February 5, 2024  
IDEA Weslaco Mechanical Upgrades

## **ADDENDUM NO. 2**

01 IDEA WESLACO  
MECHANICAL & ELECTRICAL RENOVATION PLAN (SERVICE YARD)  
SCALE: 1/4" = 1'-0"

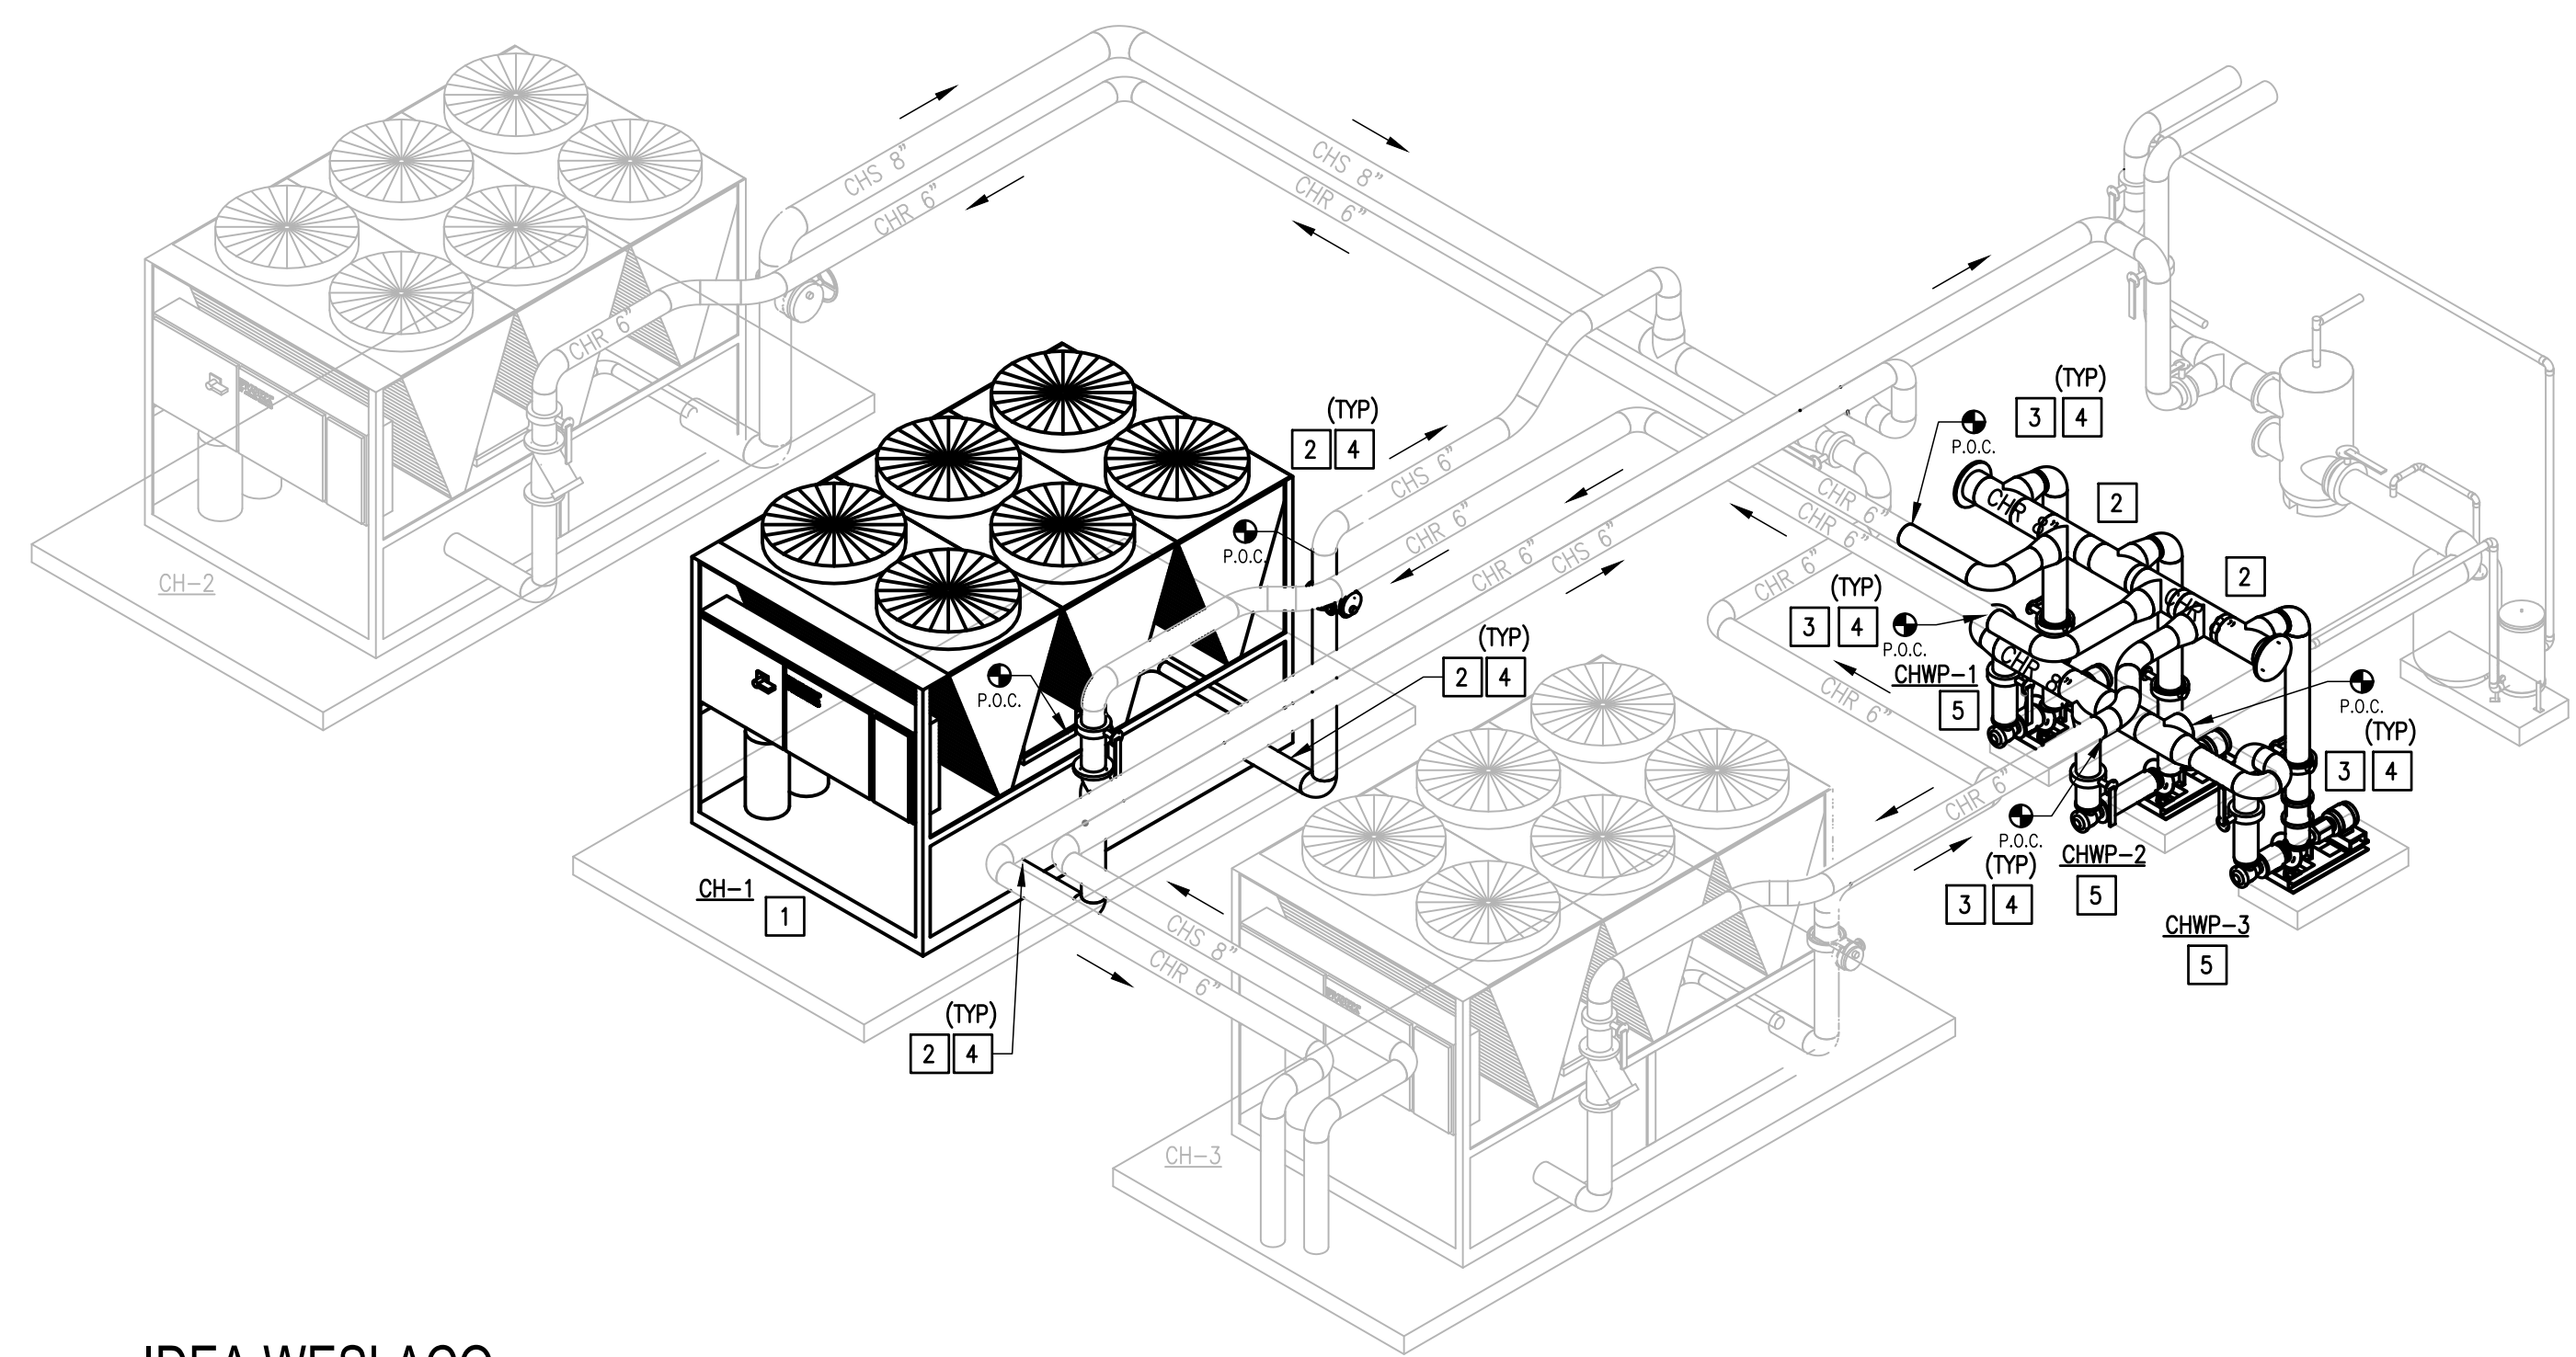
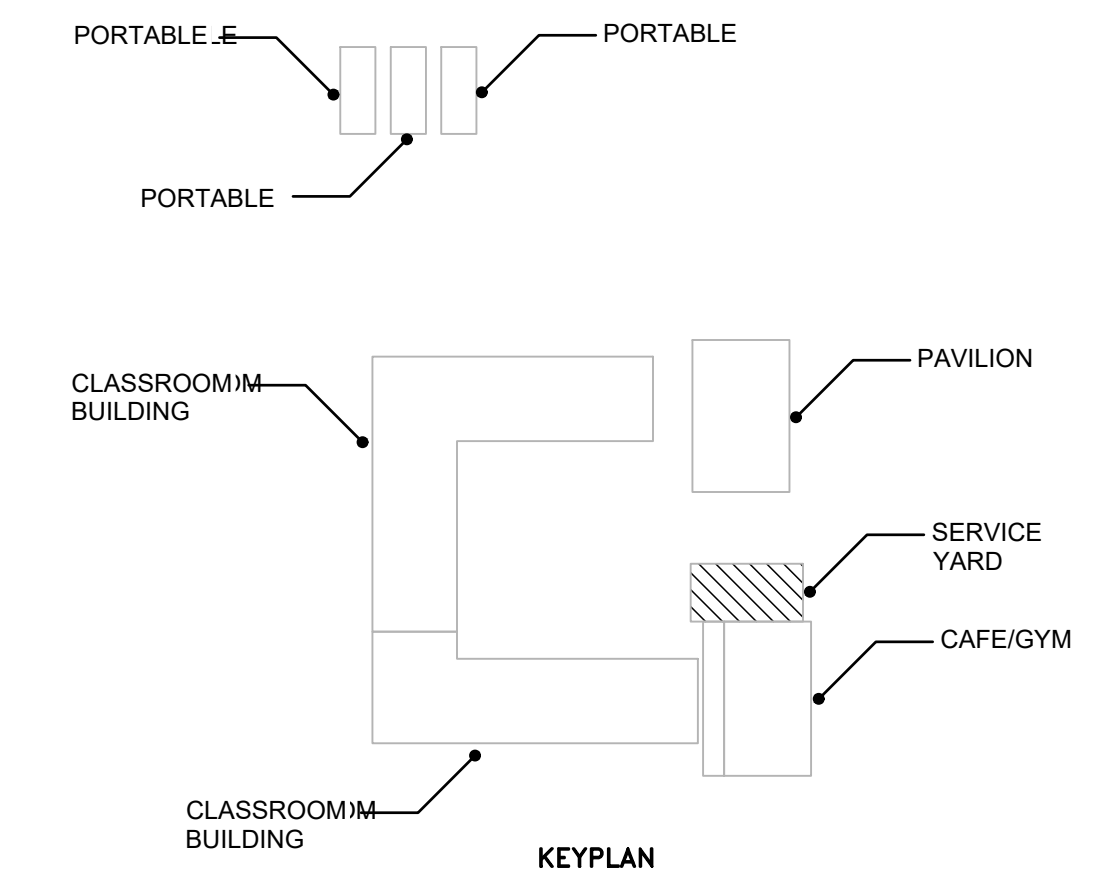
1. Sheet ME2.1:
  - a) Revised Mechanical & Electrical Demolition Plan. See attached sheet.
2. Sheet ME2.3:
  - a) Revised Mechanical & Electrical Renovation Plan. See attached sheet.
3. Sheet ME3.1:
  - a) Revised Mechanical & Electrical Renovation Plan. See attached sheet.
4. Sheet ME5.1:
  - a) Revised Equipment Connection Schedule. See attached sheet.
  - b) Revised equipment schedules. See attached sheet.
